CITY OF FRANKLIN
PLAN COMMISSION MEETING*
FRANKLIN CITY HALL COUNCIL CHAMBERS
9229 W. LOOMIS ROAD, FRANKLIN, WISCONSIN
AGENDA
THURSDAY, MAY 7, 2020, 7:00 P.M.

**CITY OF FRANKLIN****REPORT TO THE PLAN COMMISSION**

Project Name:	Copart of Connecticut, Inc.
Project Location:	10082 S 124th Street. Not Assigned/891-9010002, 939-9994-000, and 939-9995-000
Property Owner:	Mills Hotel Wyoming (891-9010-002), Franklin Mills, LLC (939-9995-000), and Mathson, Daniel L & Virginia K (Mathson, Robert ET AL) (939-9994-000)
Applicant:	Daniel Szczap. Bear Development, LLC Mason Laycock. Copart of Connecticut, Inc.
Current Zoning:	M-1 Limited Industrial District
Proposed Zoning:	M-2 General Industrial District
2025 Comprehensive Plan:	Business Park and Areas of Natural Resource Features
Applicant's Action Requested:	Recommendation of approval of the Rezoning and approval of the proposed Site Plan.

DETAILS

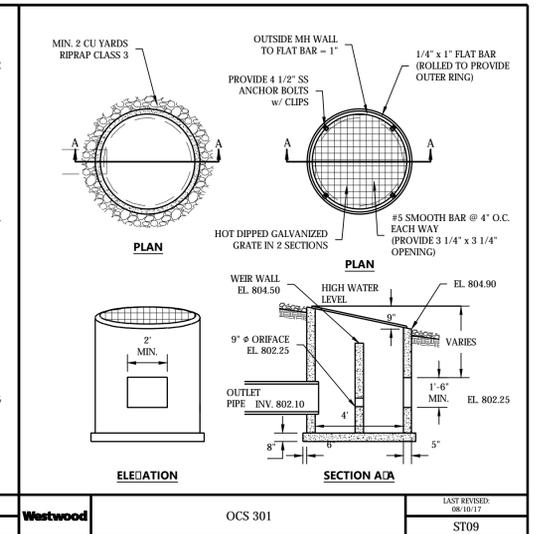
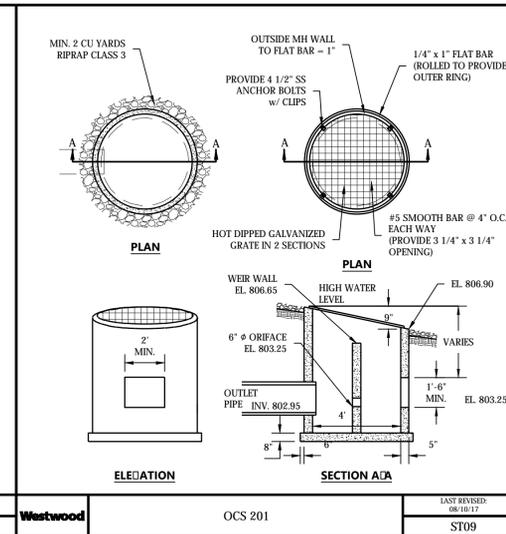
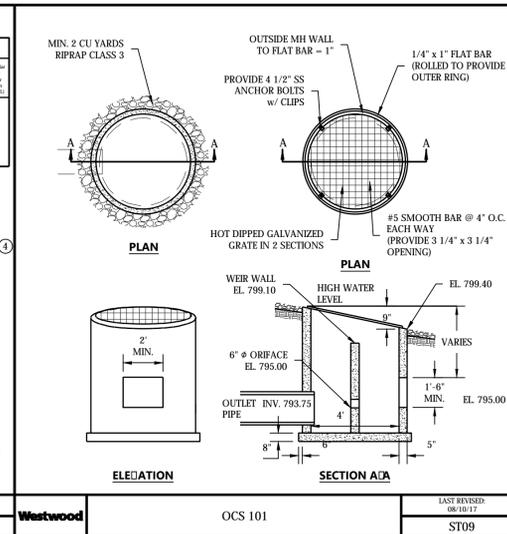
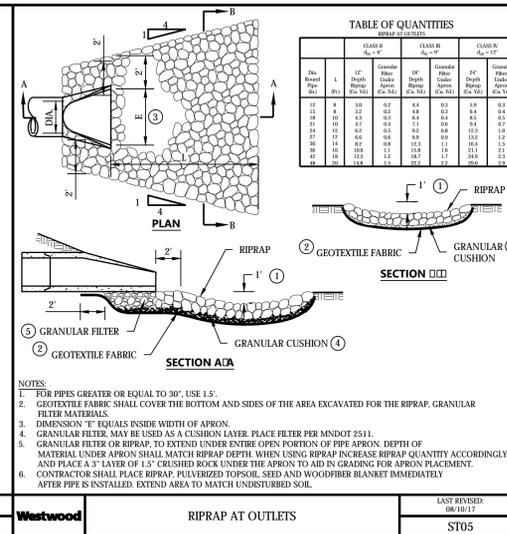
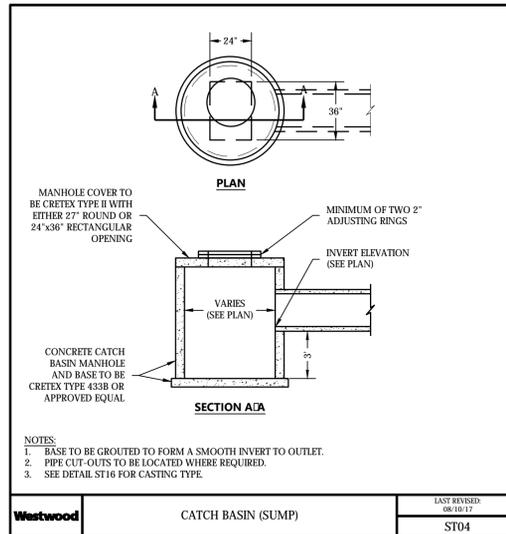
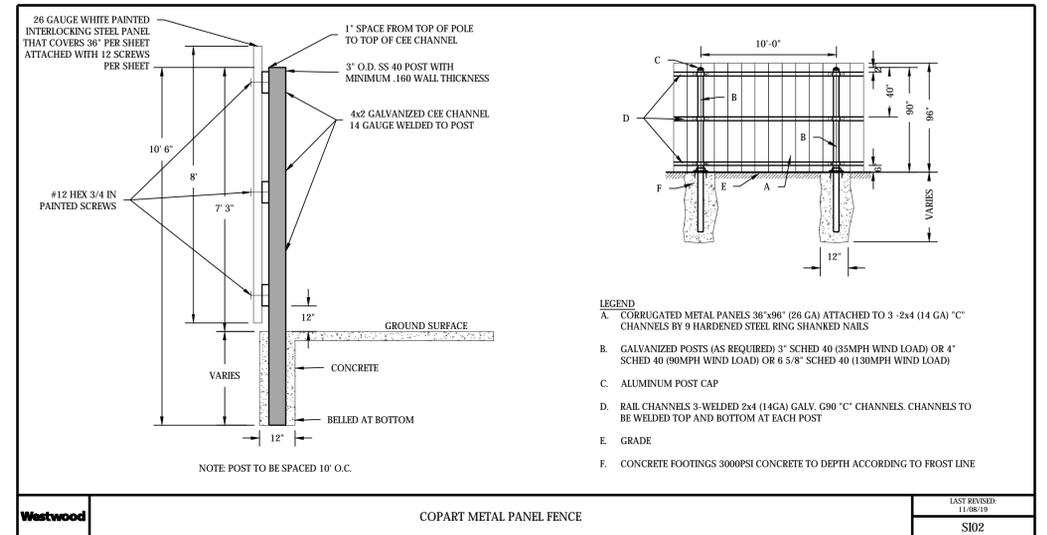
3. Approval of the proposed fences with a height of 8 feet, including a metal panel fencing and a decorative masonry fencing, as shown in plan sheet 13/16 “Details”.

Staff comment: In memorandum dated March 13, 2020, staff recommended landscape plantings between the metal panel fencing and South 124th Street. The applicant has addressed this recommendation.

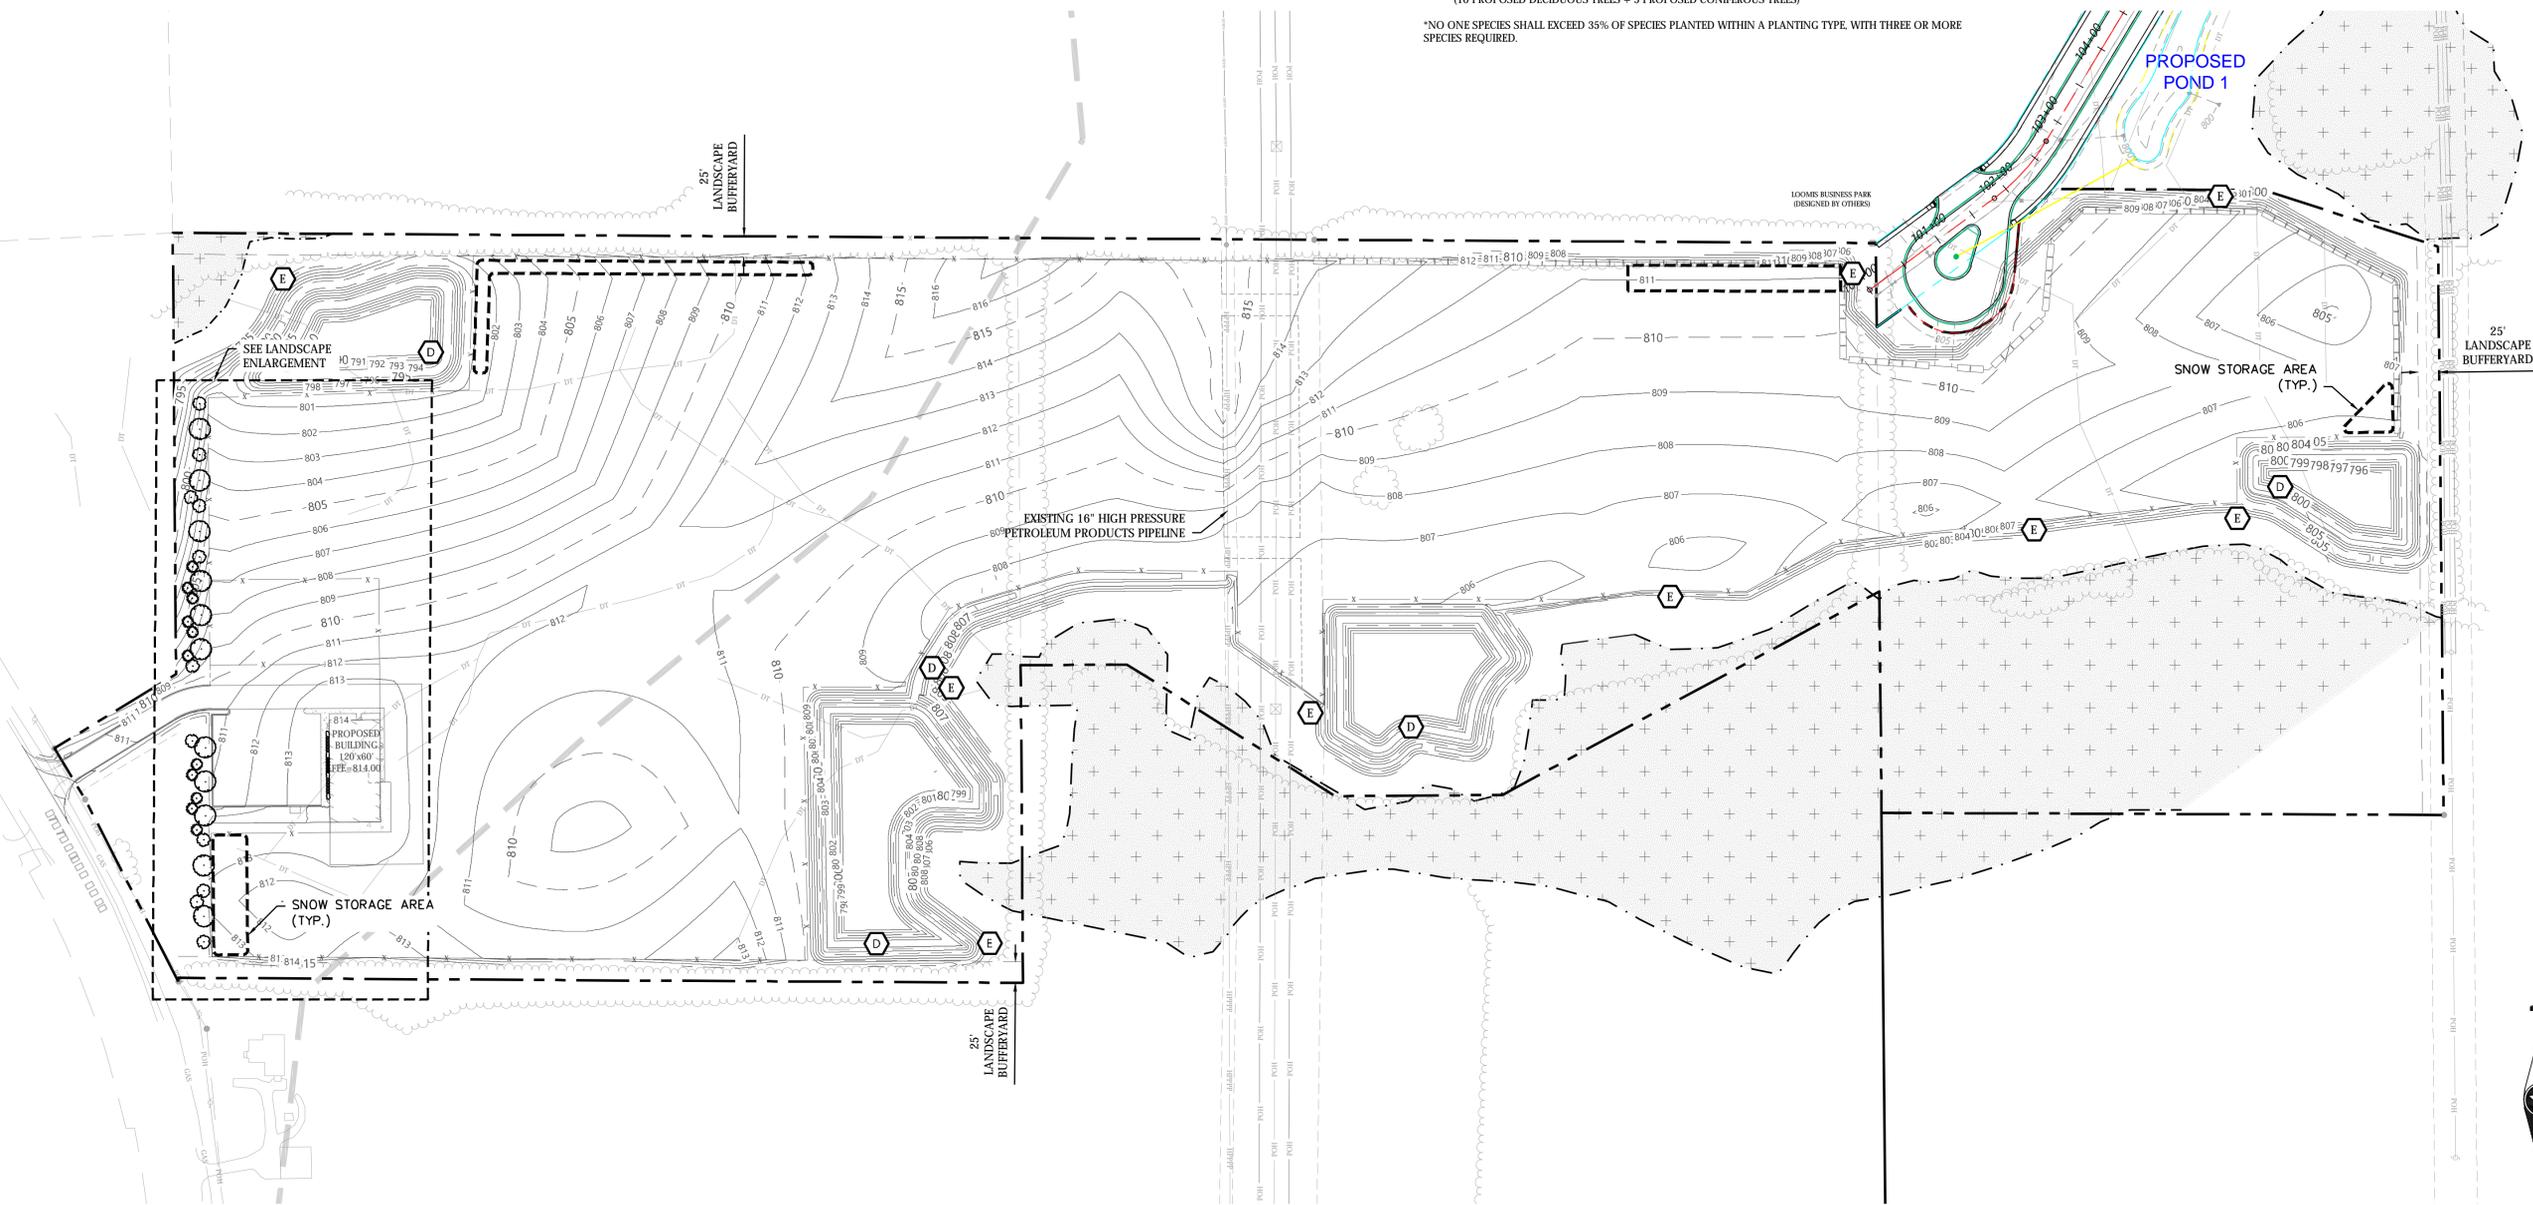
The UDO requires one planting of each type (Canopy/Shade Trees, Evergreens, Decorative Trees, and Shrubs) per five provided parking spaces. With 41 proposed parking spaces, nine plantings of each type are required. However, as the property abuts residentially zoned properties, an additional 20% of plantings is required. Therefore, 11 plantings of each type are required.

Per UDO Section 15-5.0303.D., permanent, on-site irrigation is required for all new living landscape areas. The applicant is proposing temporary irrigation until the plantings are established. According to the applicant: *planting species have been specifically chosen to be tolerable of drought conditions, so permanent irrigation should not be needed.*

Staff comment: Permanent irrigation is a requirement of the UDO. Staff is proposing two alternatives: permanent irrigation and/or a 2-year planting guarantee.

- Pursuant to Unified Development Ordinance §15-5.0303.D., the applicant shall revise the Landscape Plan to include permanent, on-site irrigation for all new living landscape areas.

- Pursuant to Unified Development Ordinance §15-5.0303.G.3., any plant materials included in an approved landscaping plan that do not survive a plant establishment period of two years after installation shall be replaced by applicant, owner(s) of the property, successors and assigns, with plant material(s) of the same or like species of equal size within the next planting season, but in any event, within six months of the plant material(s)' demise.

CERTIFIED SURVEY MAP NO. _____

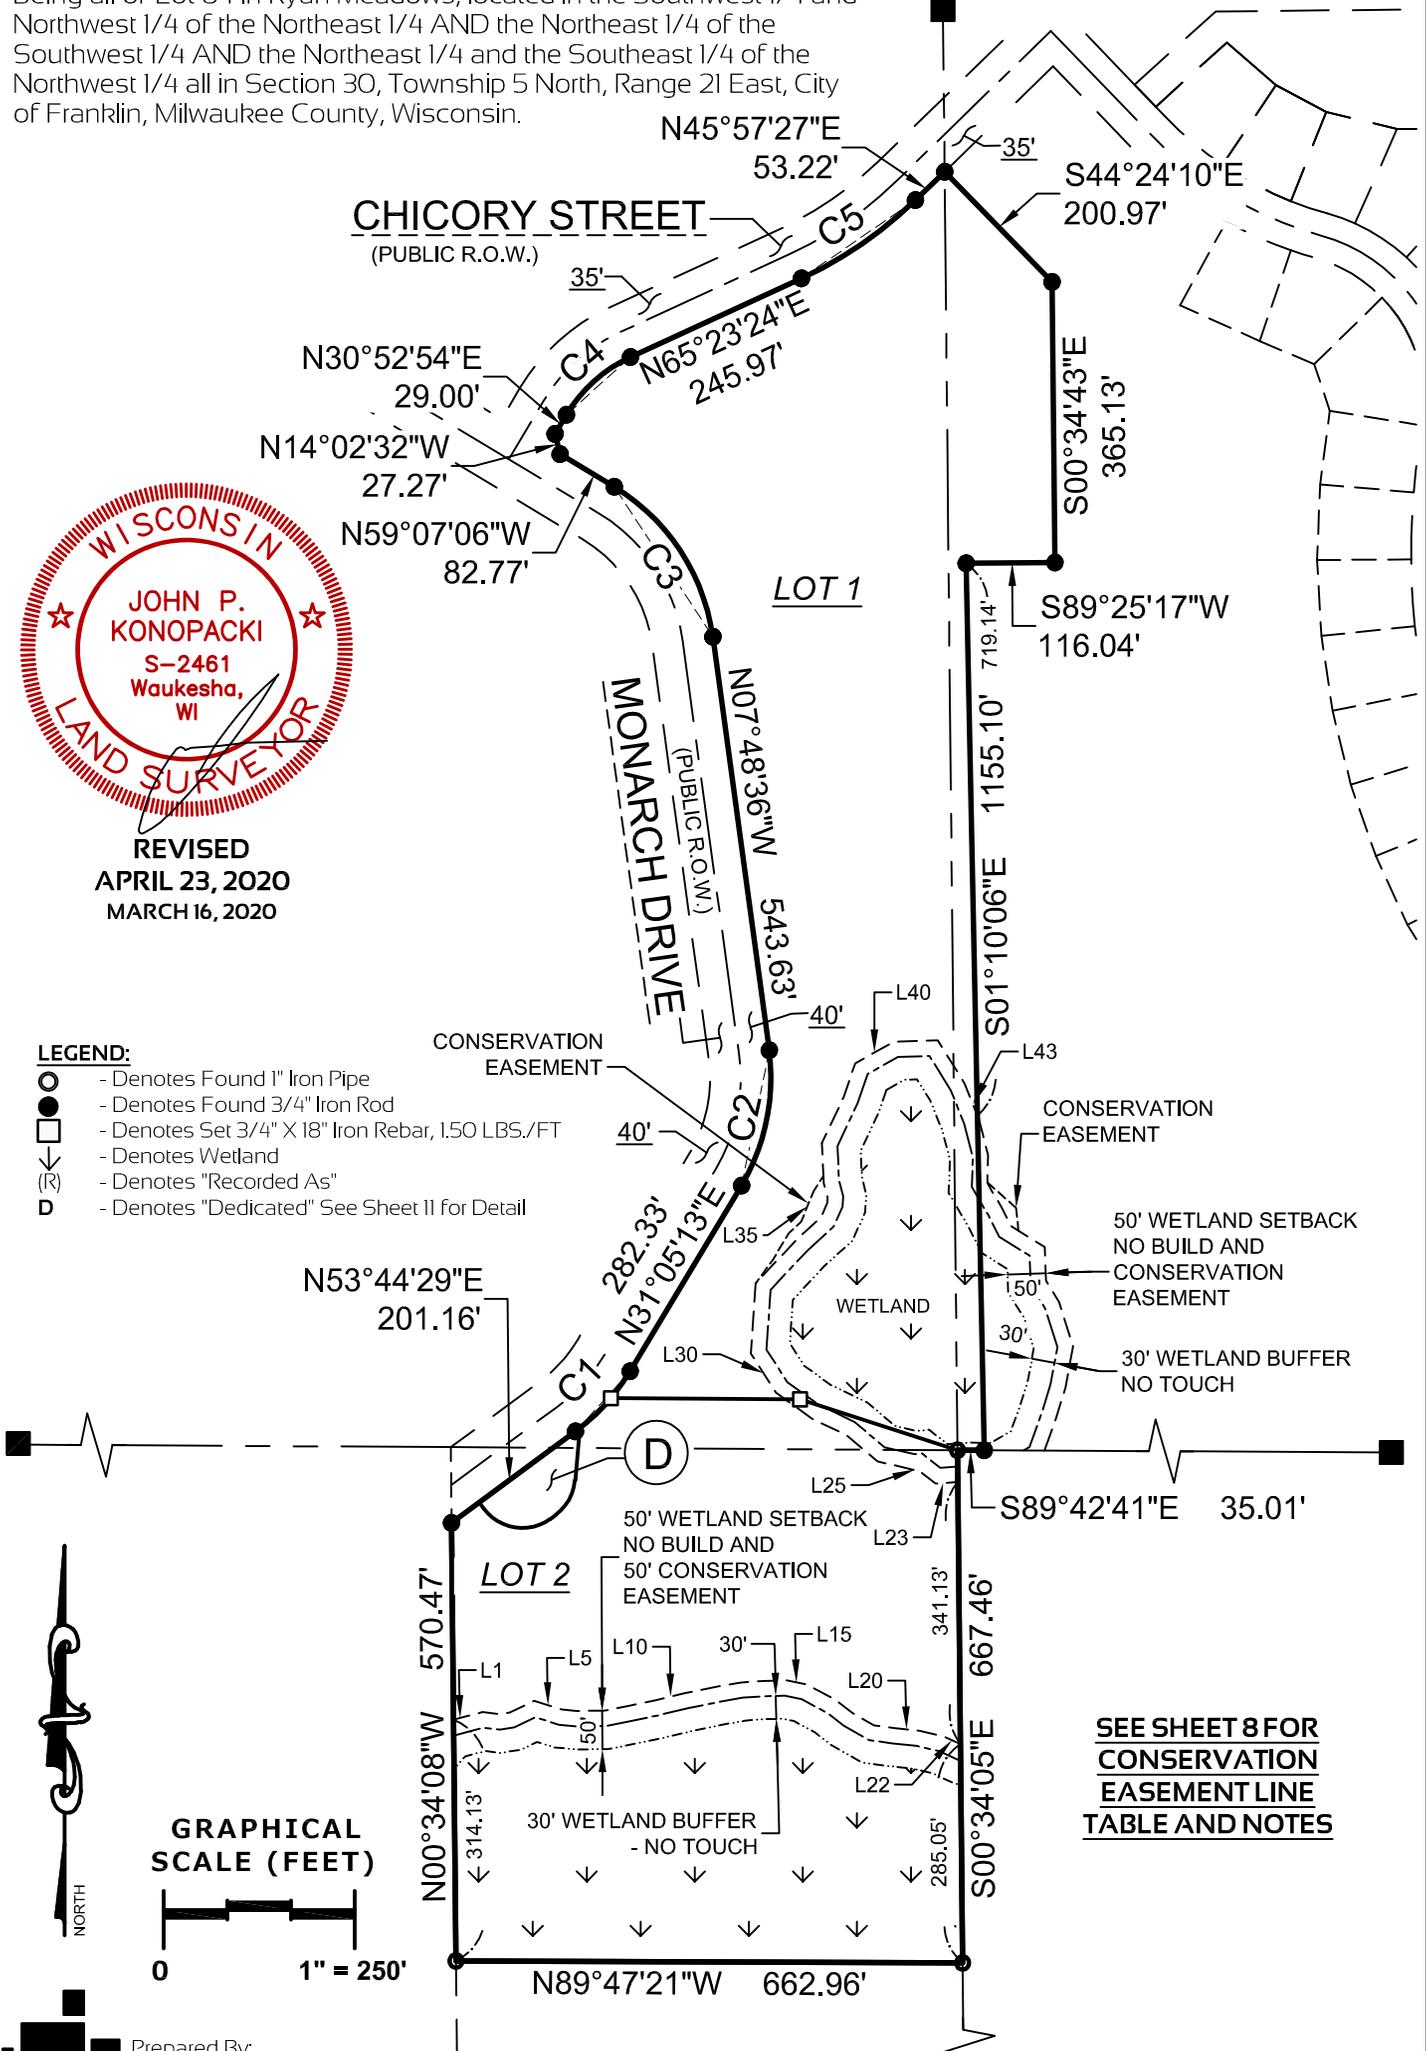
- b. Owner, Subdivider, Land Surveyor. Name and address of the owner, Subdivider, and Land Surveyor. – It is recommended that the owner/subdivider label on Sheet 5 be moved to Sheet 1.
Owner/Subdivider information has been moved to Page 1 per the City's request.

3. Sheet 3 does not show the 30-foot wetland buffer, which is shown on Sheet 2. Please include the 30-foot Buffer notation throughout the CSM.
The 30-foot wetland buffer has been added at the request of the City.
